UNITED STATES PATENT AND TRADEMARK OFFICE

APPLICATION NO.	FILING DATE	FIRST NAMED INVENTOR	ATTORNEY DOCKET NO.	CONFIRMATION NO.
10/788,931	02/27/2004	James Gregory Schroth	GP-303037	9545

Office Action Summary	Application No.	Applicant(s)	
	10/788,931	SCHROTH ET AL.	
	Examiner	Art Unit	
	Debra Wolfe	3725

DETAILED ACTION

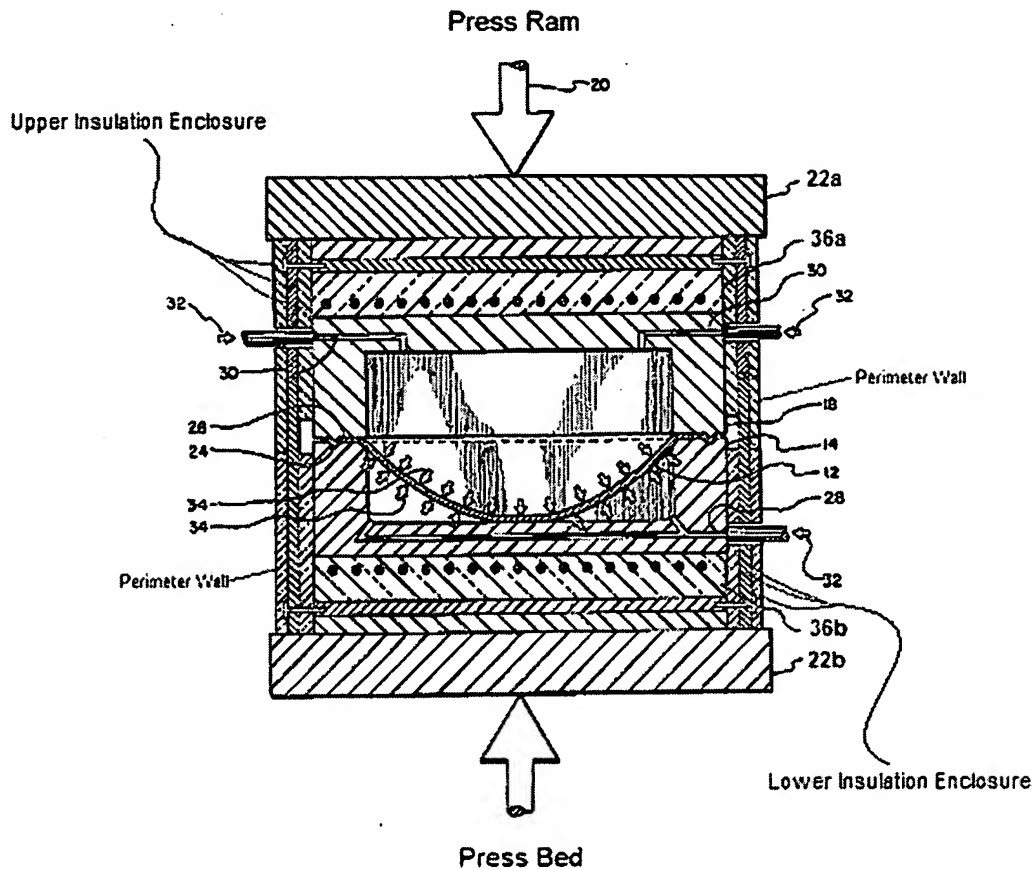
1. Claims 1-3, 7 and 10 are rejected under 35 U.S.C. 102(b) as being anticipated by Ghosh (U.S. Patent # 4,352,280). Ghosh discloses a compression forming apparatus for sheet material having an upper and lower heater plate (36) mounted to a non-heated press, via platens (22) mounted there between and to the press, wherein the heater plates are integrally heated; a first non-integrally heated forming tool (upper die portion 18) is mounted to the upper heater plate (36) and a second non-integrally heated forming tool (lower die portion 14) is mounted to the lower heater plate (36) whereby the forming tools (18, 14) are separately heated by the heater plates; a first and second insulation enclosure including a base portion positioned between each upper and lower heater plate and the presses (See col. 5, line 11) and a perimeter wall (See FIG below) surrounding each upper and lower heater plates and the first and second forming tools (18, 14) whereby when the apparatus closes together the upper insulation enclosure fits within a portion of the lower insulation enclosure to define a closed vessel thereby insulating the forming tools (18, 14) from the surrounding environment (See FIG below; notice different markings on perimeter wall).

2. Claim 13 is rejected under 35 U.S.C. 102(b) as being anticipated by Ghosh (U.S. Patent # 4,352,280). Ghosh discloses a compression forming apparatus for sheet material having a first integrally heated heater plate (36a) mounted to a press bed with a first layer of insulation (See

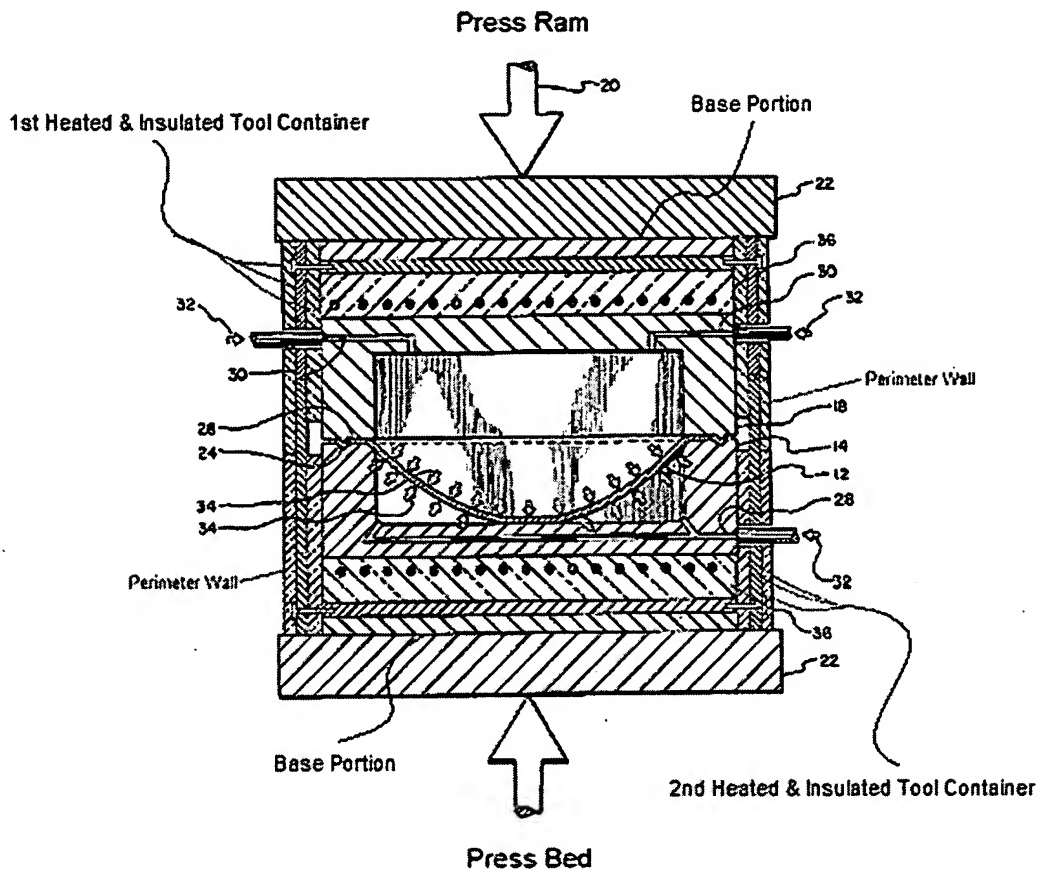
4. Claim 11 is rejected under 35 U.S.C. 103(a) as being unpatentable over Ghosh (U.S. Patent # 4,352,280) in view of Herdzina (U.S. Patent # 5,277,047). Ghosh discloses a compression forming apparatus for sheet material having a first heated and insulated tool container (See FIG below) including a tool heater plate (heater 36) adapted for attachment to a platen (22) of a press (See col. 4, line 59), an insulation enclosure having a base portion (See FIG below) between the tool heater plate (36) and platen (22) (See col. 5, line 22) and a perimeter wall portion (See FIG below) extending in a substantially perpendicular direction away from the

base portion and surrounding tool heater plate (36), a forming tool (upper die portion 18) mounted to the tool heater plate (36) such that the forming tool (18) is separately heated by the tool heater plate (36); and a second heated and insulated tool container (See FIG below), opposed to the first heated and insulated tool container (See FIG below), including a second tool heater plate (36b) adapted for attachment to an opposed platen (22b) of a press (See col. 4, line 59), a second insulation enclosure having a base portion between the second tool heater plate (36b) and the opposed platen (22b) and a perimeter wall portion (See FIG below) extending in a substantially perpendicular direction away from the base portion and surrounding second tool heater plate (36b), a second forming tool (lower die portion 14) mounted to the second tool heater plate (36b) such that the second forming tool (14) is separately heated by the second tool heater plate (36b). It is also disclosed by Ghosh when the apparatus closes together the upper insulation enclosure fits within a portion of the lower insulation enclosures to define a closed vessel thereby insulating the forming tools (18, 14) from the surrounding environment (See FIG below; notice different markings on perimeter wall). Ghosh discloses the invention substantially as claimed except for wherein a load bearing spacer is positioned between the first heater tool plate and platen and a second load bearing spacer is positioned between the second heater tool plate and platen. However, Herdzina discloses a conversion system tooling heater having a load bearing insulated spacer to minimize the heat loss to the lower chase. It is also noted that Ghosh does provide insulating plates to hold the heaters against the die and to confine the heat to the die (See col. 5, line 11). Therefore it would have been obvious to one of ordinary skill in the art at the time the invention was made to modify Ghosh with a load bearing insulating spacer as taught by Herdzina in order to confine the heat to the die and minimize heat loss.
